MISSISSIPPI POWER & LIGHT COMPANY
Helping Build Mississippi

SUBJECT: Grand Gulf Nuclear Station
Units 1 and 2
Docket Nos. 50-416 and 50-417
File 0260/16360
Control of Heavy Loads
AECM-81/427

RESPONSES TO REQUESTS
FOR
INFORMATION IN SECTION 2.1
OF ENCLOSURE 3 TO DECEMBER 22, 1980
LETTER FROM D. EISENHUT

FIGURE 4

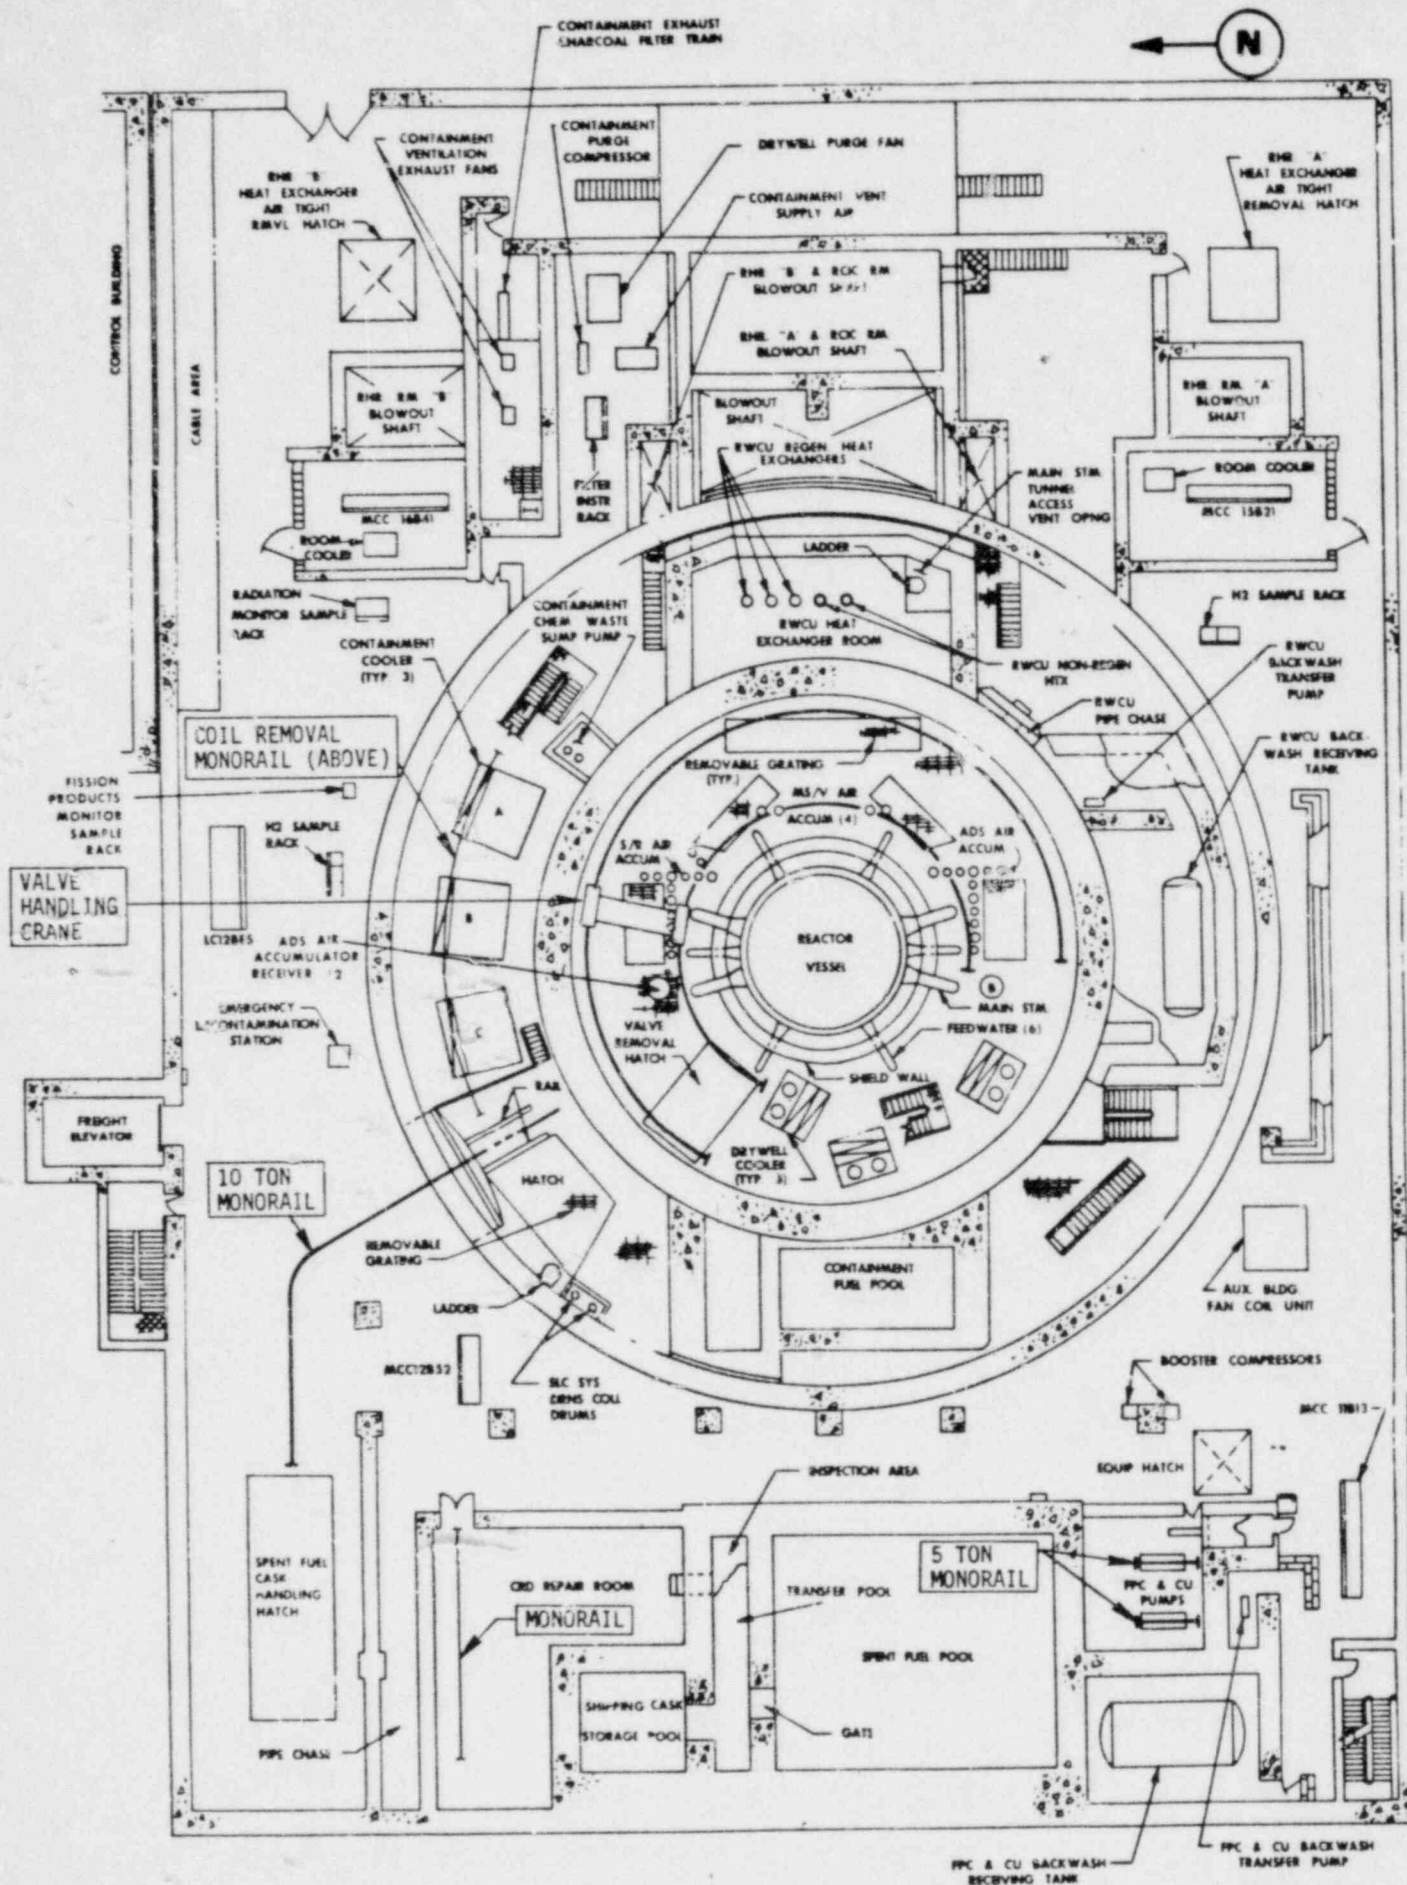
ITEM 2: Justify the exclusion of any overhead handling system from the above category by verifying that there is sufficient physical separation from any load-impact point and any safety-related component to permit a determination by inspection that no heavy load drop can result in damage to any system or component required for plant shutdown or core decay heat removal.

RESPONSE: Monorails, hoists, and cranes in the Turbine Building and Radwaste Building have been excluded on the basis that no safe shutdown equipment is located in these areas. Although this plant contains a large number of monorails and hoists in the Auxiliary and Containment Buildings that were installed to facilitate maintenance, the handling systems were located so as to minimize the potential for damaging plant equipment when they are used. In general, plant equipment and cabling is well separated from locations where heavy loads would be handled. The review of plant handling systems, plant arrangements, and location of safe shutdown equipment found that the monorail, hoist, and crane systems listed in Table 2 can be excluded from further detailed consideration for the reasons described below. These handling systems are highlighted on Figures 1-7.

FIGURE 8
HEAD STRONGBACK CAROUSEL

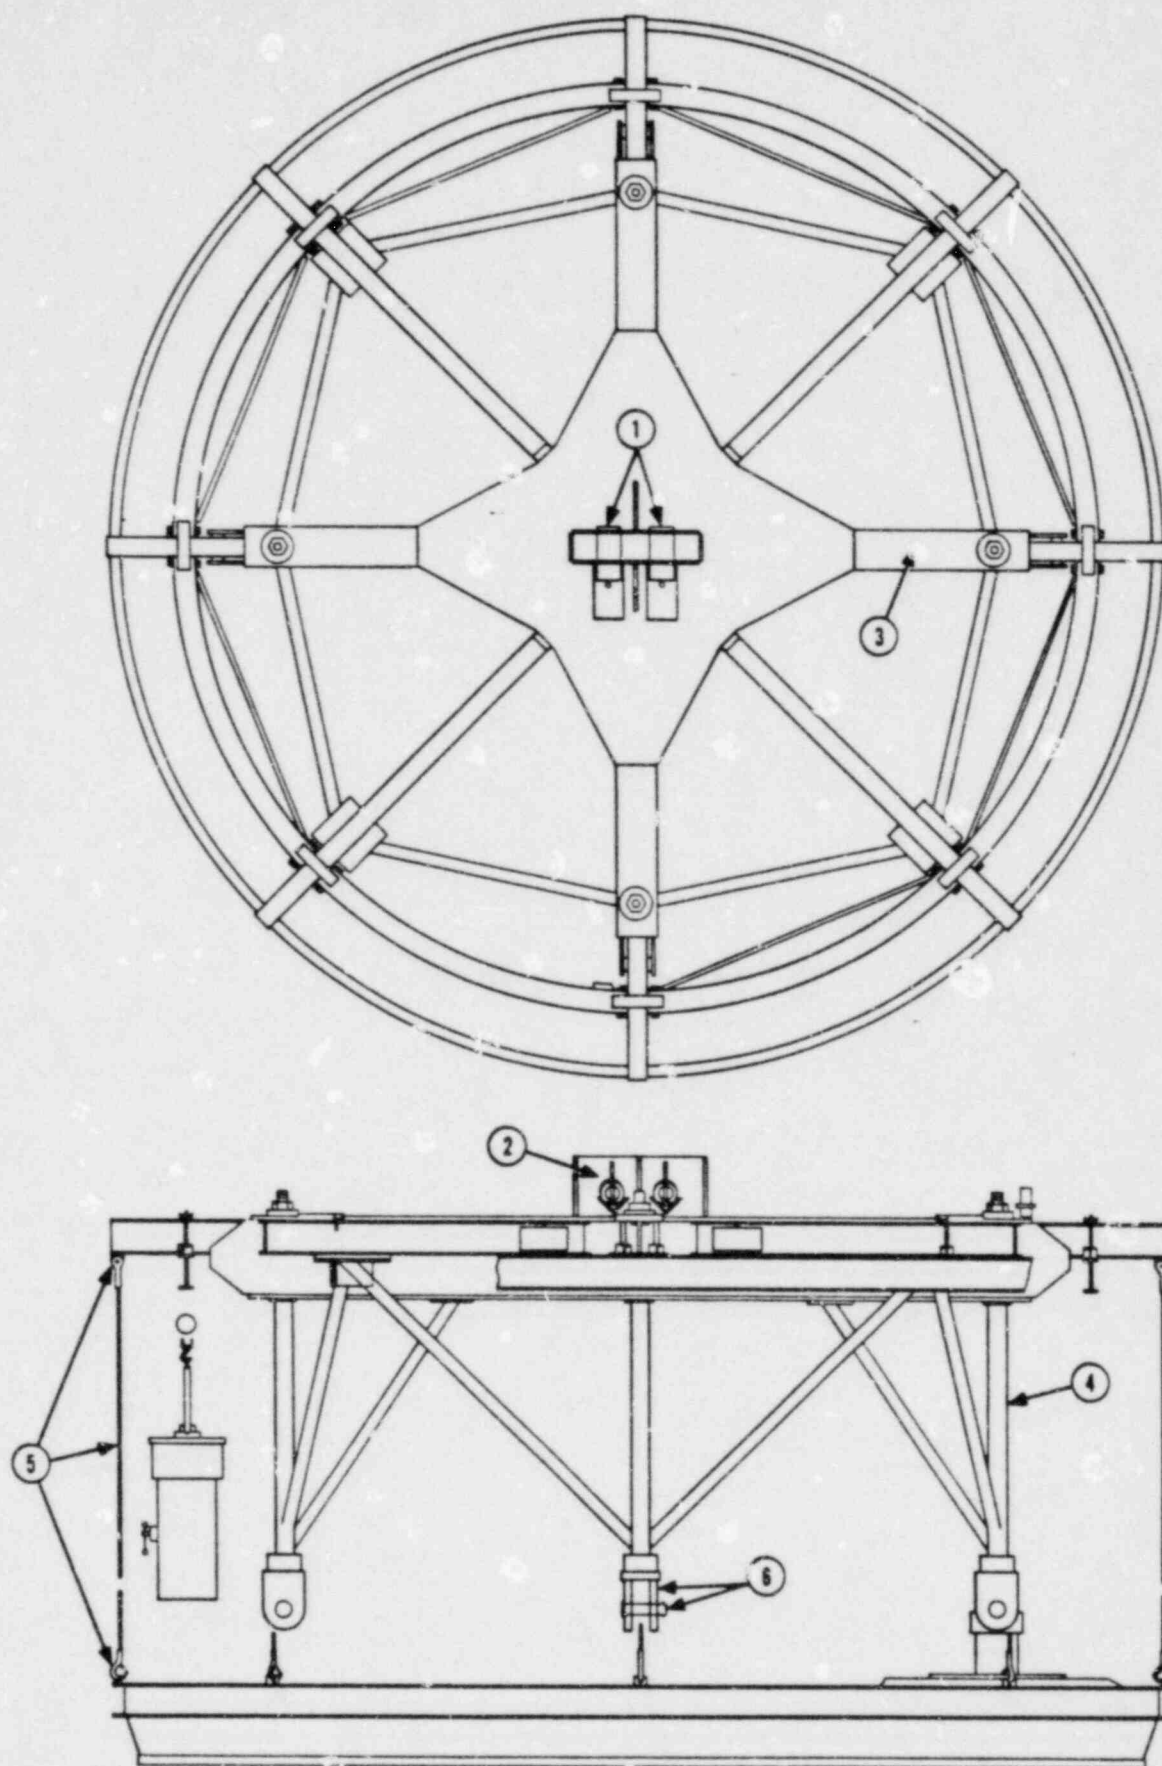
(1) Head Strongback Carousel (Figure 8)

The head strongback carousel combines the functions of stud tensioning and relaxation, nut and washer handling and storage, and reactor vessel head transport. The strongback frame is a cruciform structure of box beams with four intermediate radial beams which together provide an eight-point support for the carousel track. A lift box is welded to the top of the frame and carries two lift pins for attaching the frame to the crane hook. Four laterally braced support legs extend vertically down from the box beam support arms to the reactor vessel head lifting lugs. Eight slings are attached at the ends of the support arms and intermediate radial beams to carry the nut tray storage ring.

Each of the four vertical supports consists of a tubular assembly comprising a support pipe, lifting clevis, and two brace arms which are bolted to

the frame. The lifting clevis rod is housed within the support pipe and extends through sleeves in the frame arms where it is secured by a backing plate and nut. A threaded tube in the lower end of the support pipe provides an adjustable extension.

FIGURE 9
DRYER AND SEPARATOR STRONGBACK

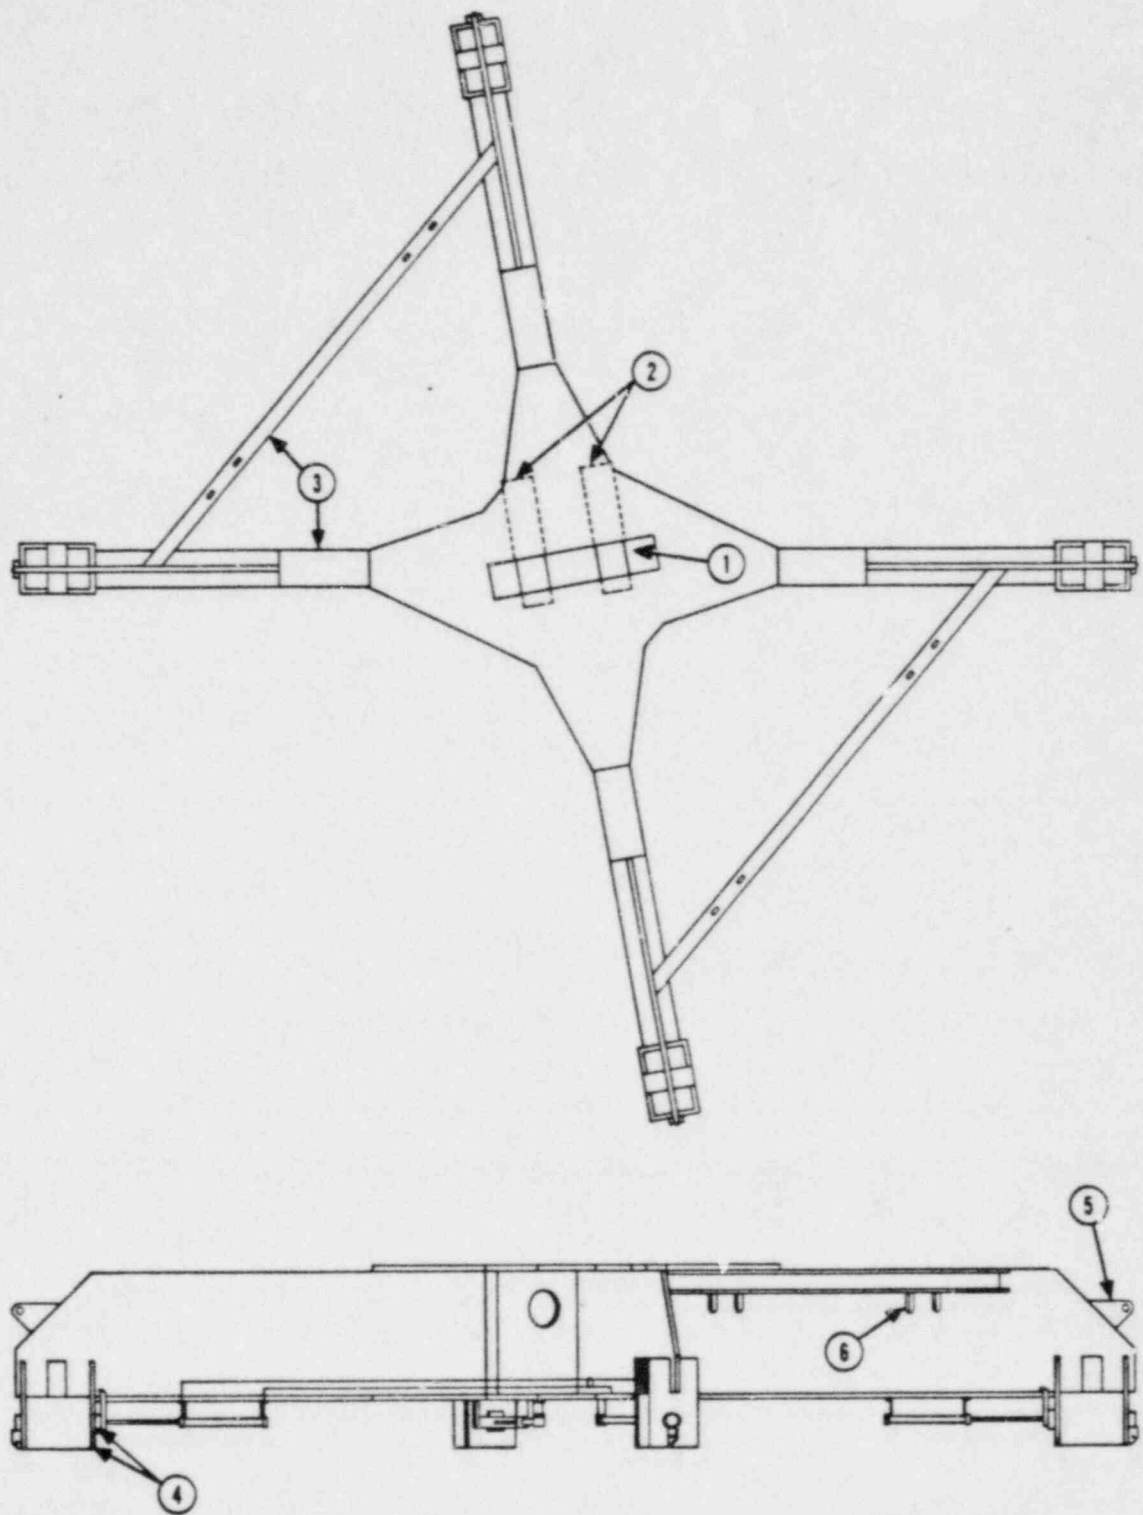
(2) Dryer and Separator Strongback (Figure 9)

The dryer and separator strongback is used during refueling or reactor servicing operations to remove and install the steam dryer and the shroud-head and steam separator. The strongback is also used to remove and install the auxiliary platform components which include the vessel platform and vessel platform polar track.

The dryer and separator strongback consists of a frame which is made of four quadrangular steel beams aligned to intersect at a central hook box. The beams are flanged at the bottom and welded to top and bottom support plates. The top plate has a cut-out for the crane sister hook. The ends of the tapered beam are fitted with lift sockets for remote engagement of socket pins to the lifting eyes of the dryer and the separator. There are two separate compartments in each lift socket: the outer compartment for dryer engagement and the inner compartment for separator engagement. The socket pins are actuated by double-acting air cylinders which are mounted at the ends of the beams.

A lifting eye is also provided at the end of each beam to connect four single-legged slings that are used to lift the vessel platform polar track. Lifting eyes are provided on the braces between each pair of support beams for attaching lifting cables to lift the vessel platform. Separate wire rope cable slings are used for the vessel platform and the platform polar track.

FIGURE 10
 DRYWELL HEAD LIFTING FRAME

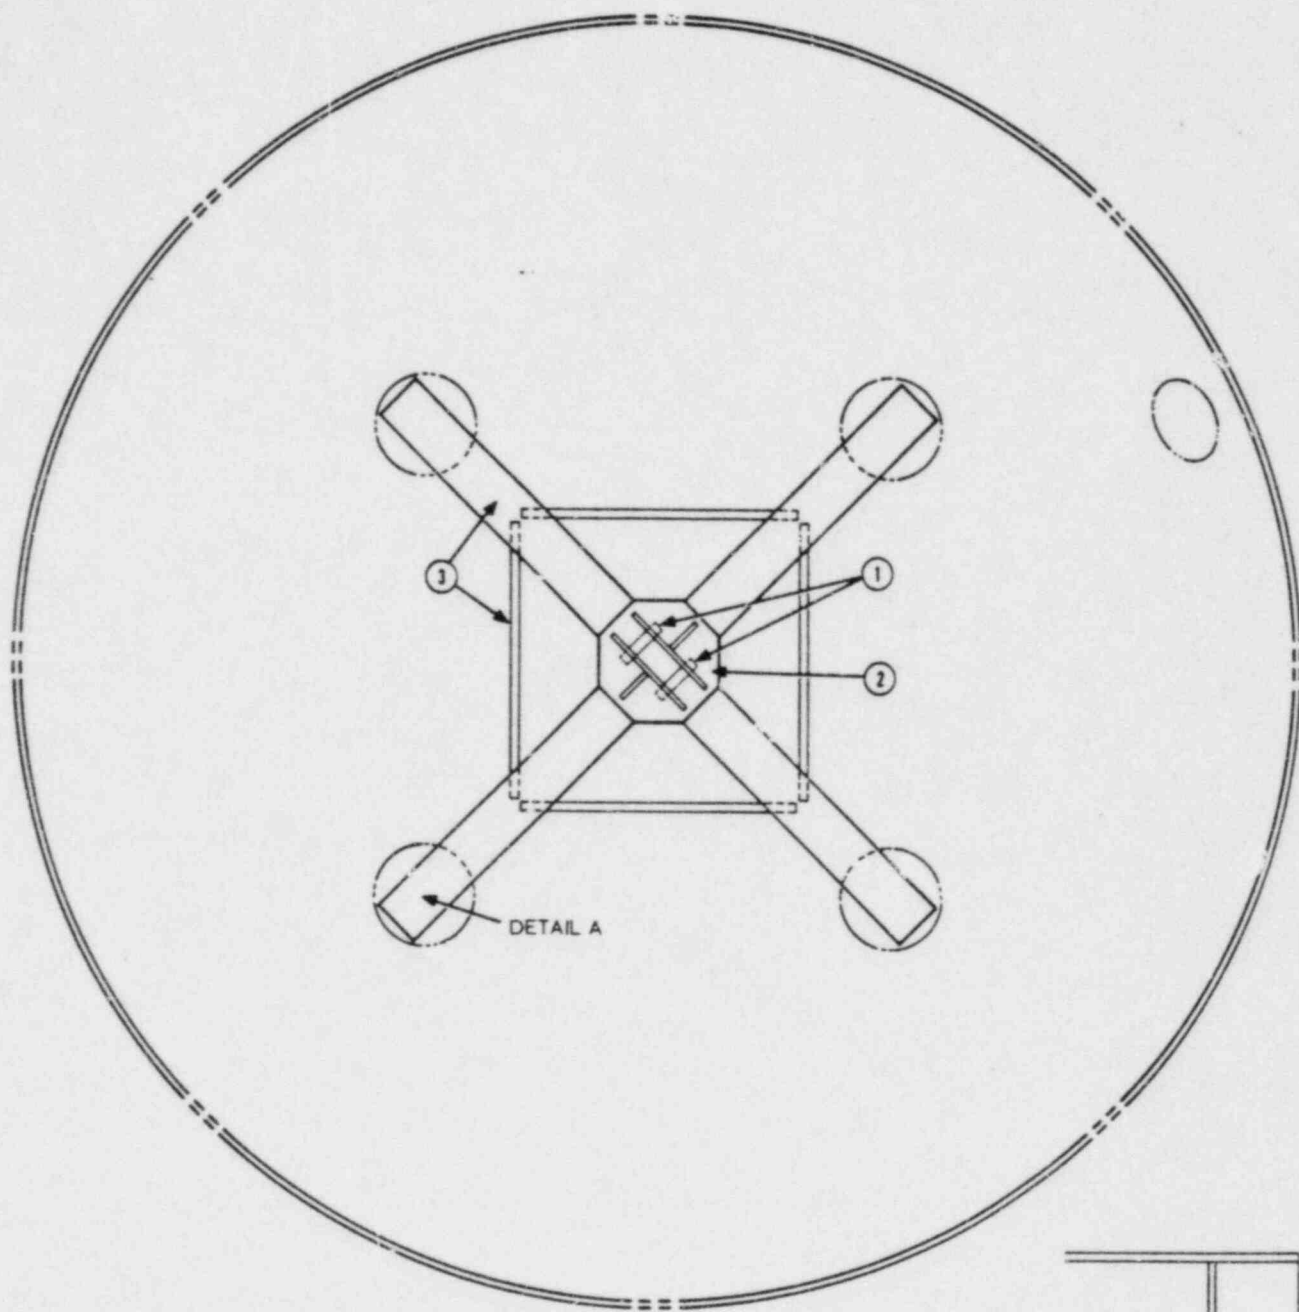
(3) Drywell Head Lifting Frame (Figure 10)

The drywell head lifting frame (or strongback) is used to lift the drywell head and the head insulation support structure.

The lifting frame consists of a cruciform I-Beam structure with four radial arms which are fitted with lifting lugs at the outer end of the arms. A plate structure is bolted to the top surface of the lifting arms and carries the crane hook pins.
